Staff Report to the Zoning Administrator

Application Number: **07-0666**

Project Description: Proposal to rectify a red tag by recognizing a replacement single family dwelling on site with an existing garage and a shed (to be demolished).

Environmental Planning Completeness Comments

Figure
3

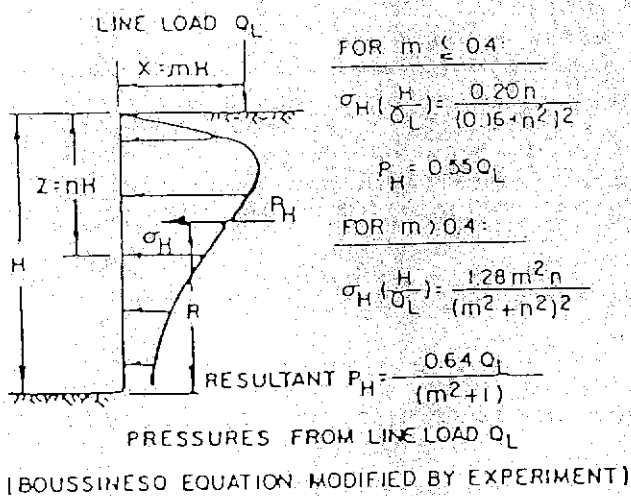
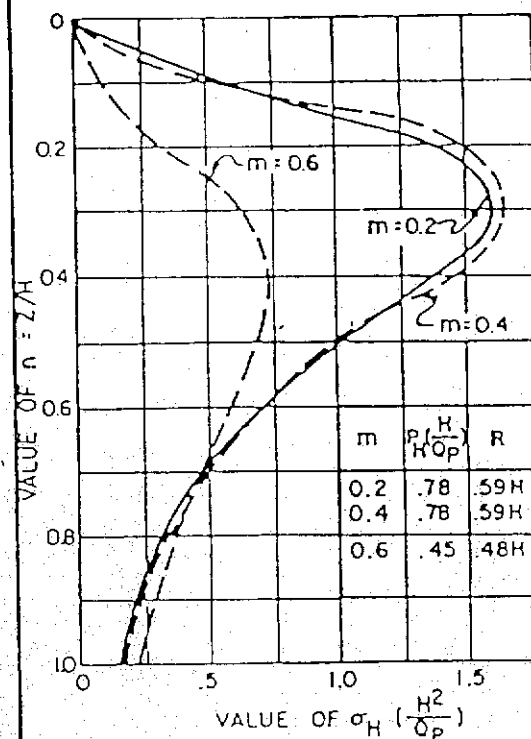
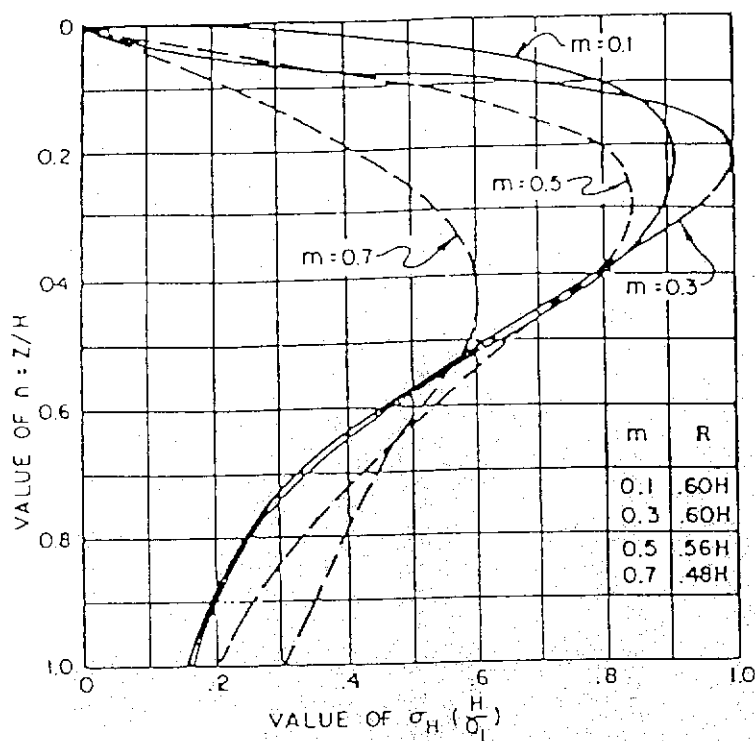
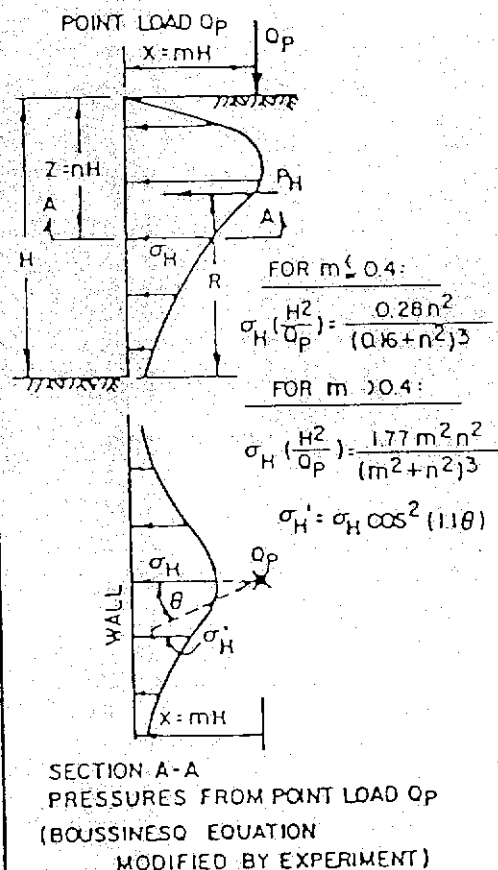
- e. Pressure due to any surcharge loads from adjacent footings, traffic, etc., should be analyzed separately. Pressures due to these loading can be supplied upon receipt of the appropriate plans and loads. Refer to **Figure 3** for a Surcharge Pressure Diagram.
